Technical Service Handbook

Transmission: gearbox warning lamp on, P0C2900 and possibly additional event memory entries - 0GC gearbox

Transaction No.: 2049489/16

Figure 1 - components of OGC gearbox

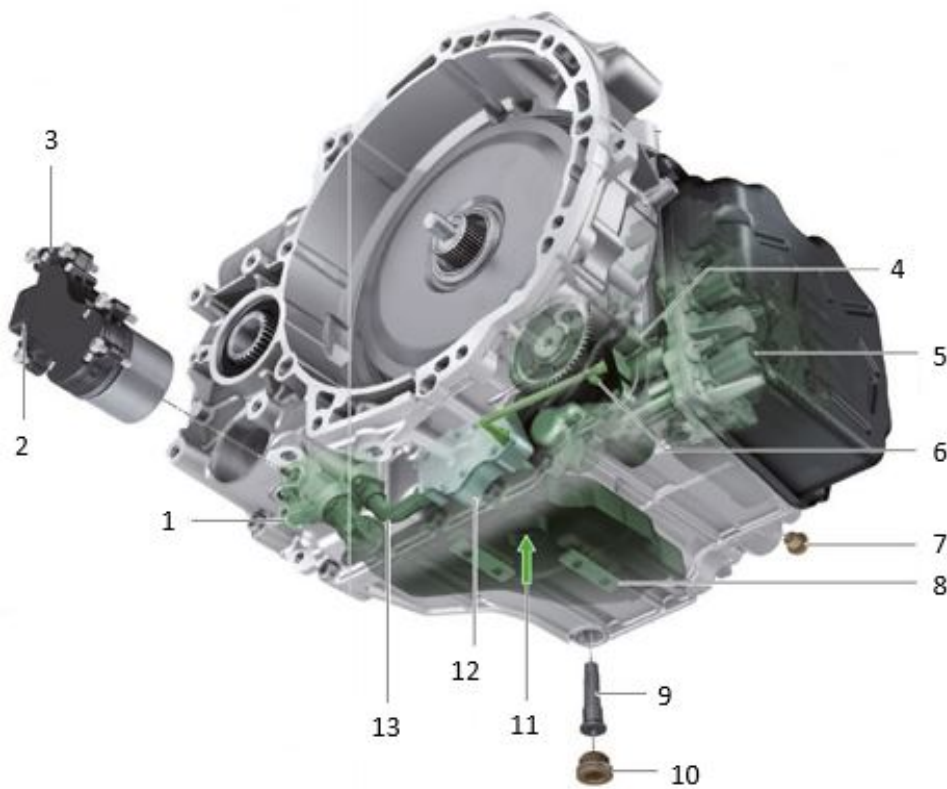
Component-related issue on auxiliary hydraulic pump 1 (-V475-) for gear oil (item 1 - figure 1).

Production change

Optimised auxiliary hydraulic pump 1 for gearbox oil (-V475-) introduced

- From gearbox production date **27.09.2017** onwards

- Replace the auxiliary hydraulic pump according to the instructions in the attachment.
